Access Compliance Report

Public Rights-of-Way (Curb Ramps)

Intersection ID: 24993	Main Street: TRESANTON_DR	Cross Street: TYNE_CT	Location:	E
ADA ID: ABADB3C70560	Ramp Type: PerpDiag	Initial Pass/Fail: Fail	Overall Compliance: No	Severity Score: 12.5
Codes/Mitigation Info/Possible Solution		Field Measurements/Component Compliance

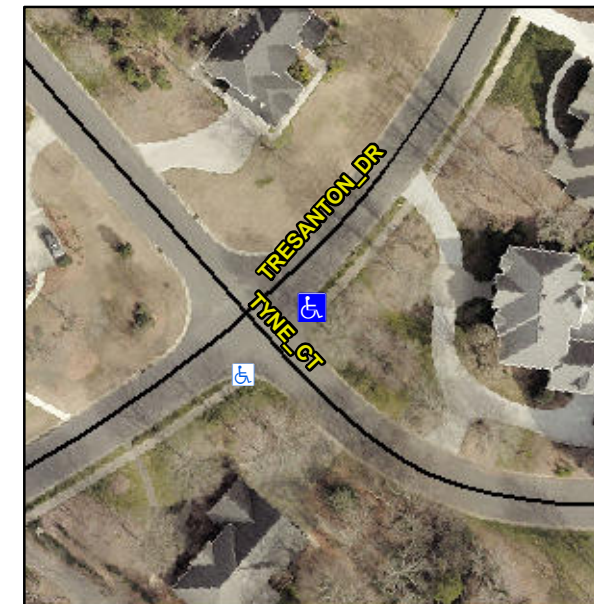
Not Found, R304.2.2

Compliance	Description	Data	Compliance	Description	Data
N/A	Ramp Length (in)	48.0	No	Ramp Slope (%)	11.3
Yes	Ramp Width (in)	48.0	Yes	Ramp XSlope (%)	1.6
N/A	Flare Type LT	N/A	N/A	Flare Type RT	N/A
N/A	Flare Slope LT (%)	N/A	N/A	Flare Slope RT (%)	N/A
N/A	Flare Traversable LT?	N/A	N/A	Flare Traversable RT?	N/A
N/A	Landing Length (in)	N/A	N/A	DWS Provided?	N/A
N/A	Landing Width (in)	N/A	N/A	DWS Contrast?	N/A
N/A	Landing Slope (%)	N/A	N/A	DWS Length (in)	N/A
N/A	Landing X Slope (%)	N/A	N/A	DWS Full Width?	N/A
N/A	Landing Curb? (Y/N)	N/A	N/A	DWS Offset (in)	N/A
N/A	Shared Landing?	N/A			
N/A	Gutter Ponding?	N/A	N/A	Gutter Slope (%)	N/A
N/A	Gutter Lip Ht (in)	N/A	N/A	Gutter X Slope (%)	N/A
N/A	Painted X Walk1?	No	N/A	Painted X Walk2?	No
	X Walk 1 Direction	To NW		X Walk 2 Direction	To SW
N/A	X Walk 1 Width (in)	N/A	N/A	X Walk 2 Width (in)	N/A
	X Walk 1 Slope (%)	3.9		X Walk 2 Slope (%)	1.3
	X Walk 1 X Slope (%)	1.0		X Walk 2 X Slope (%)	4.0

Remove & Replace Curb Ramp With Two New Directional Ramps or Equivalent.
